REMARKS

U.S. Patent Application Serial No. 10/052,732

Title: "Cylindrical AC/DC Magnetron With Compliant Drive System and Improved Electrical and Thermal Isolation" Sheet 1 of 11 Atty. Docket No.: M-12044 US

FIG. 1A (Prior Art)

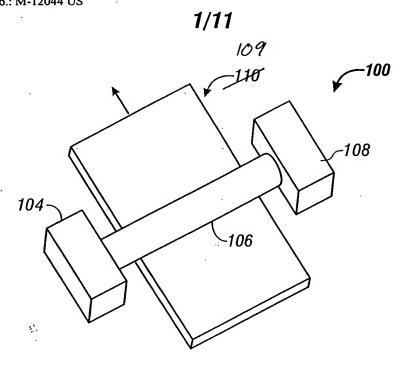
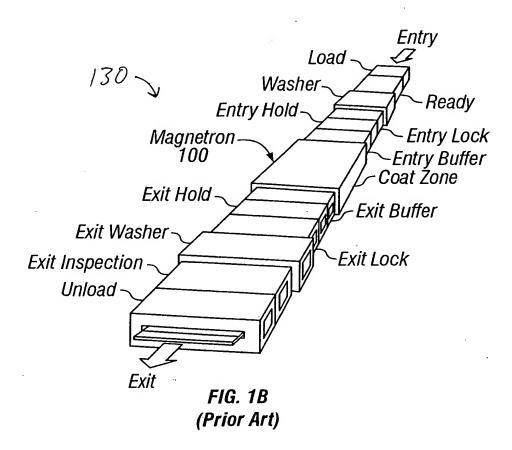
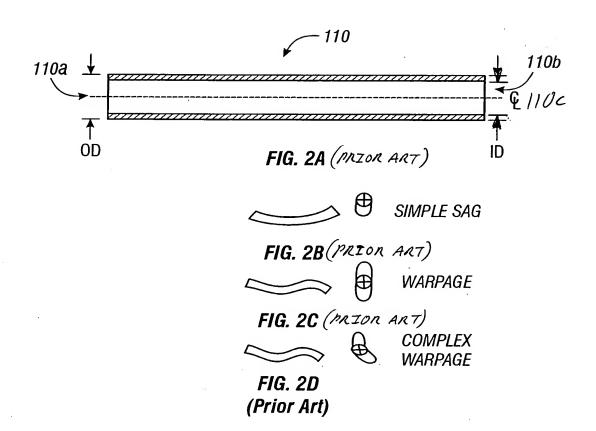
FIGURE 1: Glass sheet 110 in Figure 1A is relabeled as 109 in order to avoid conflict with target tube 110 of Figure 2. The text is amended in paragraph 0003 to reflect this change. Reference sign 130 is added to Figure 1B.

The specification is amended at paragraph 0003 to replace "glass sheet 110" with "glass sheet 109." This is to avoid conflict with "target tube 110" shown in Figure 2. Figure 1A is also amended to replace "110" by "109." Paragraph 0003 is also amended to reflect the correct spelling of the reference author "Russell J. Hill."

FIG. 3

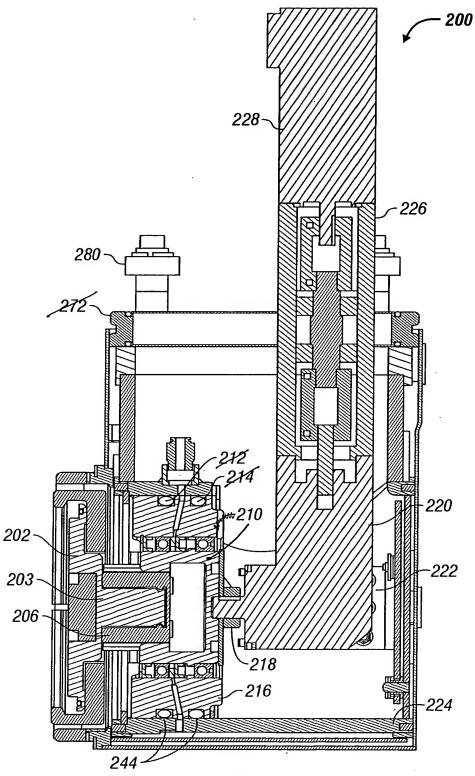
FIGURE 3: Reference signs 272, 212 and 214 are deleted. Reference sign 210 is amended to clearly indicate the correct part as shown in other figures such as Figure 5.

FIG. 4

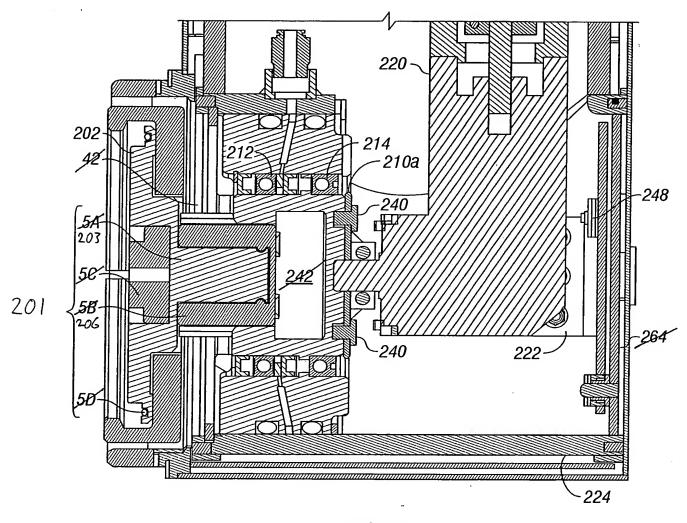
FIGURE 4: References 5A-5D of Figure 4 are deleted or amended to conform to the numbering used in other figures and to illustrate the components of reference 201. Reference signs 42, 242 and 264 are deleted. Reference sign 201 is added to Figure 4 to indicate drive assembly 201 as shown in Figure 5.
